PLN-HOB-2025-0606

423 Sandy Bay Rd House Extension

REGARDING: Proposed extension and Carport
ADDRESS: 423 Sandy Bay Rd, Sandy Bay.

REQUEST FOR INFORMATION - PLANNING

3 - PROPOSED SITE PLAN 1:200

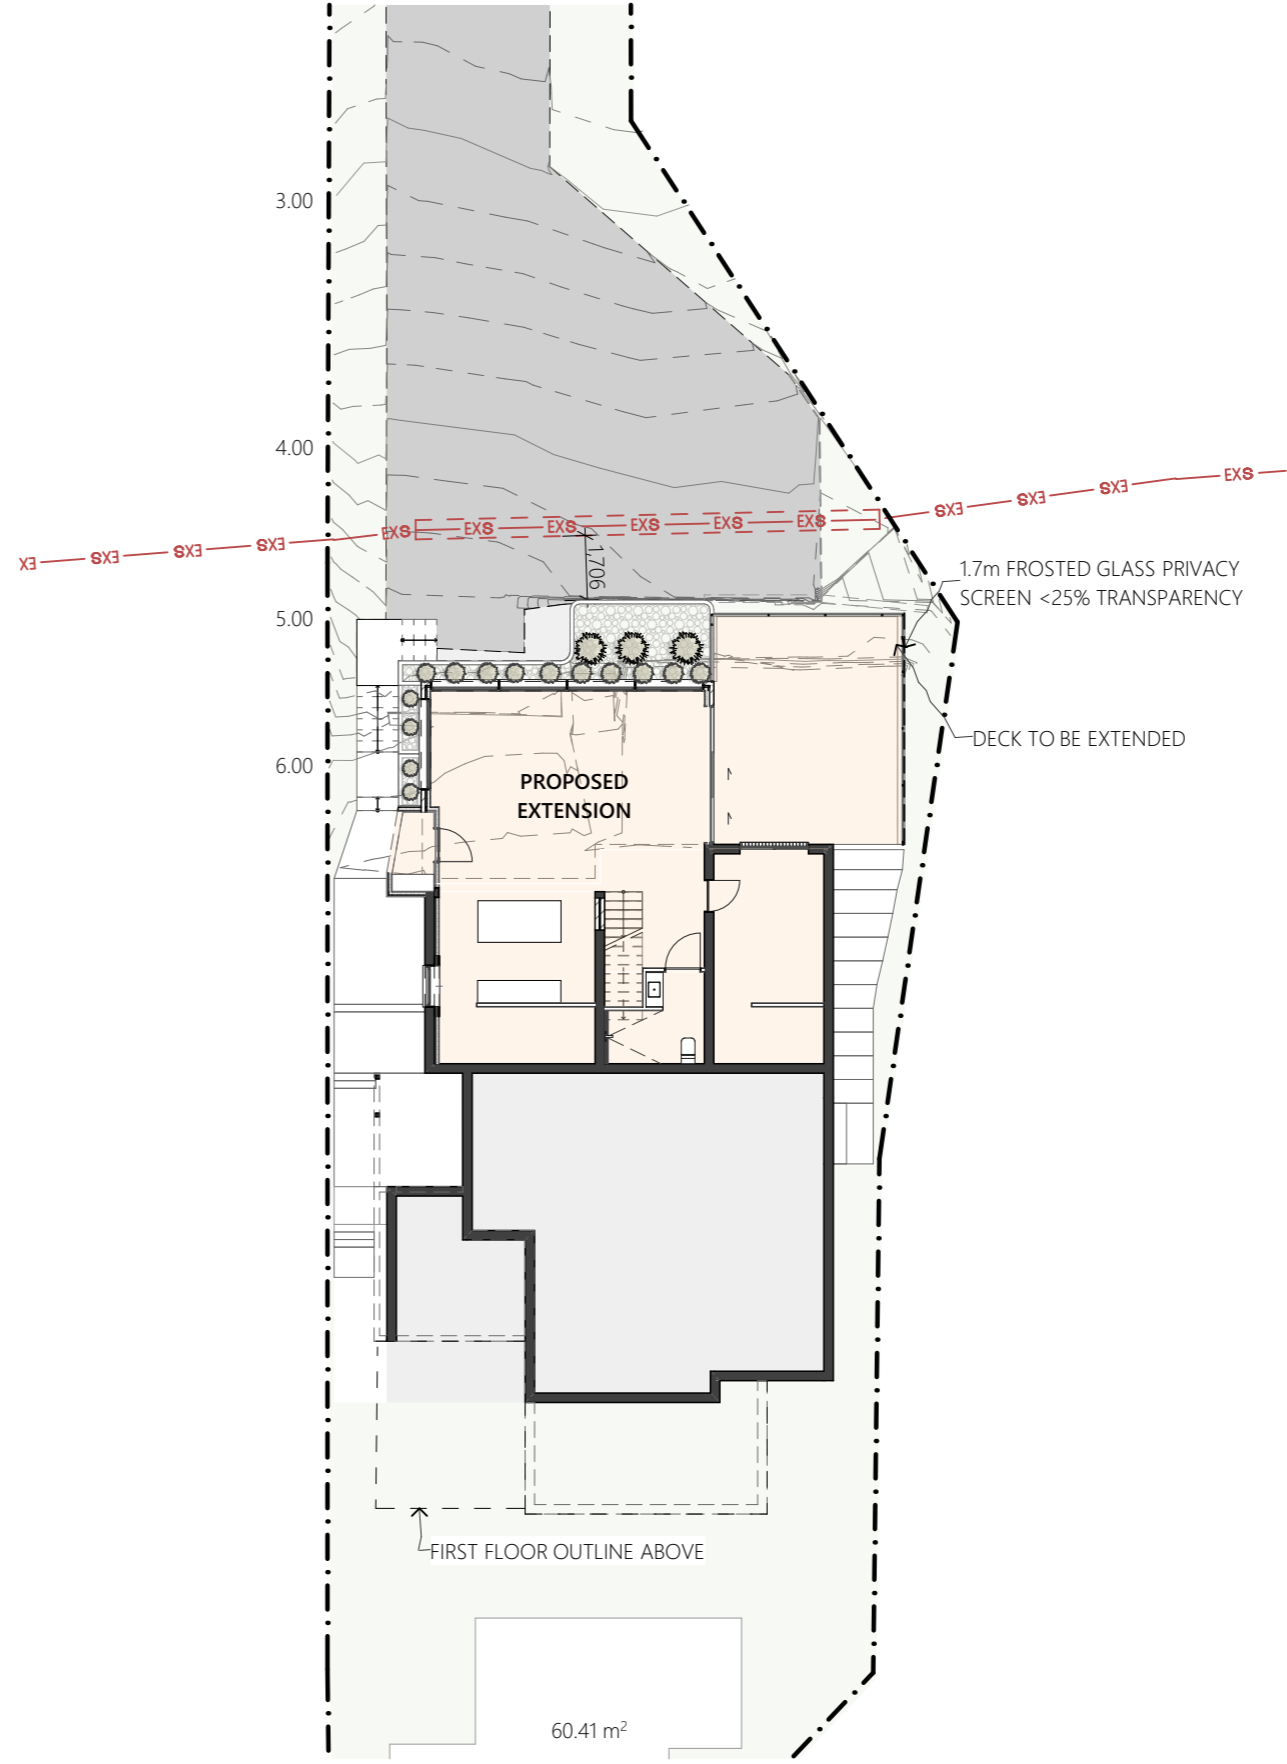
1. On a site plan/s please confirm the existing and proposed site coverage. This is the total area of the lot covered by roofed buildings, including the ancillary dwelling and any carports and outbuildings.

1. Amended plans which show the following:
 - a. The easement removed and the exact location of the DN525mm diameter sewer trunk main accurately dimensioned on the plans relative to a known datum and the proposed carport.
 - b. A note added on the plan stating how the pipe was located (e.g. TasWater infrastructure located on site by asset location contractor).
 - c. The proposed carport including eaves and gutters and footings must be located no closer than 1.0 metre to the outside of the TasWater sewer trunk main, and;
 - d. Drawing title block(s) amended to show revision number, revision date & revision description.

Additional note has been added to page DA02 specifying the existing and the proposed site coverage including outbuildings.

1. The exact location of the sewer trunk main has been determined by Utility Detection & Mapping. PDF of their survey has been provided. This has been referenced to the site boundary corner nearest the carport in the project. The located pipe has been noted and shown on *DA02 Site Plan*.

The proposed carport has been designed and located to make sure the outer extent of footings is greater than 1m from Taswater infrastructure. The carport roof framing expands over the sewer main, however it has been specified that all connections for roof framing are to be bolted together to allow for removal of the roof if vertical access to the main is required. Bolted connection is specified in *D01* on page *DA02*. Considering that the main runs underneath neighbouring buildings, slabs and driveways, we believe the proposed removable overhead structure should be sufficient for any access/loading requirements.

1 PROPOSED GROUND FLOOR PLAN
1:100

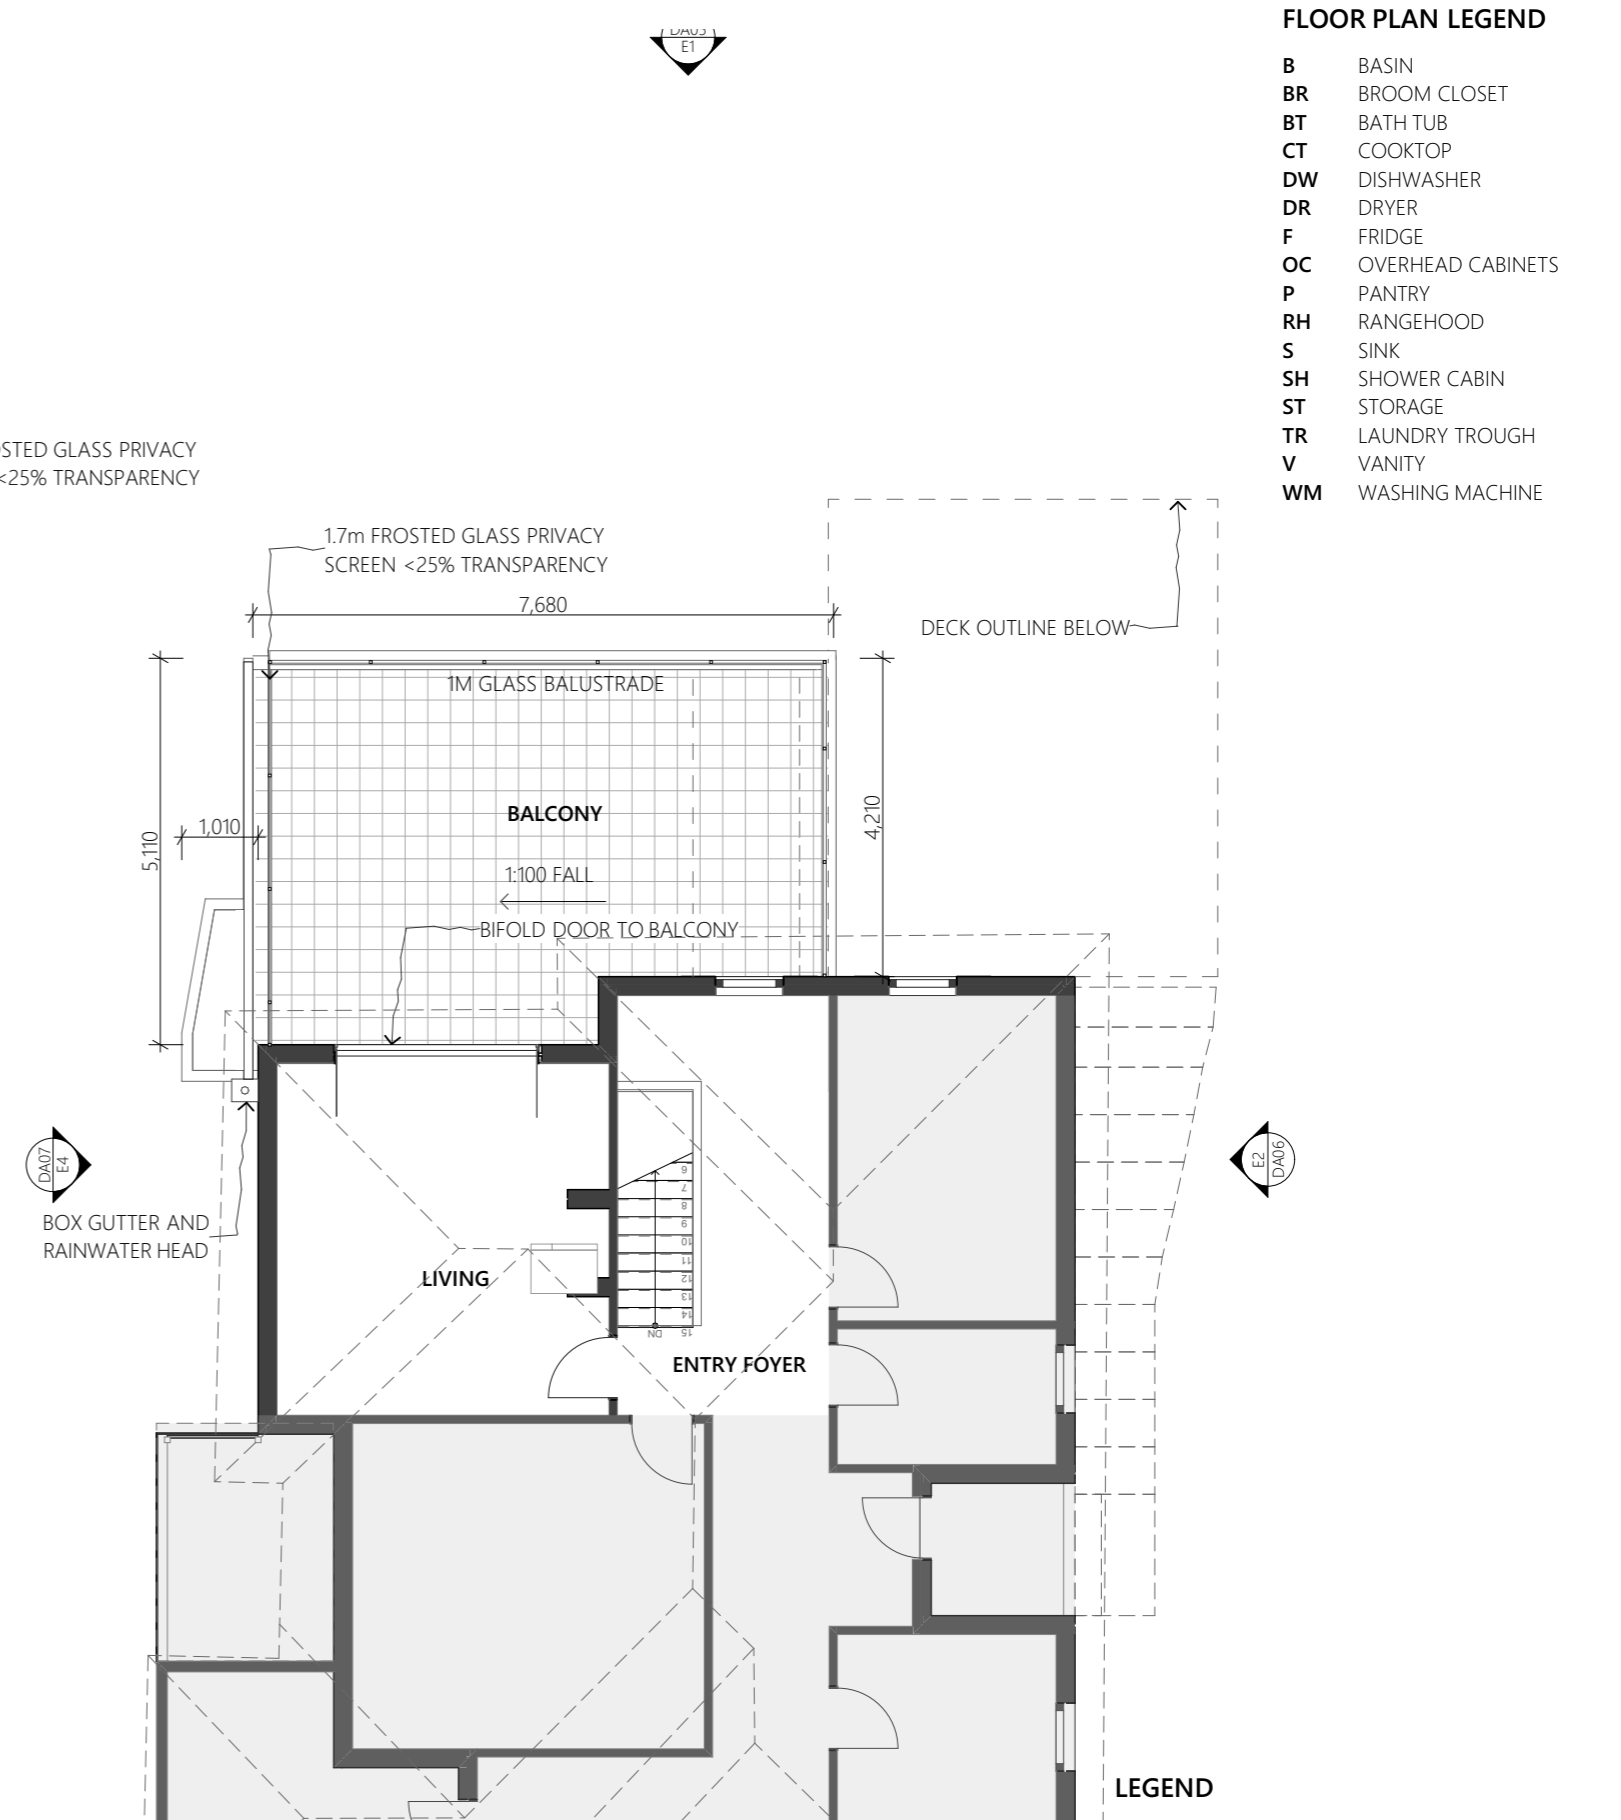
2. Confirm whether any measures are proposed to minimise overlooking of the adjoining lot from the north-east corner of the proposed ground floor deck, where the surface level is over 1m from existing ground level. If so please provide details or explain why it would not be required.

The proposed ground floor deck has a corner section of approximately 1mx0.5m where the surface level is over 1m from existing ground level, however it does not exceed any more than 1.1m above the ground level at any point. As can be seen on the satellite image and site photos the boundary fenceline is heavily vegetated on the neighbouring side, with little to no access to this area of the property adjacent the side boundary:

Any minor overlooking of adjacent property would be negated by the inaccessibility to this area and privacy created by established vegetation.
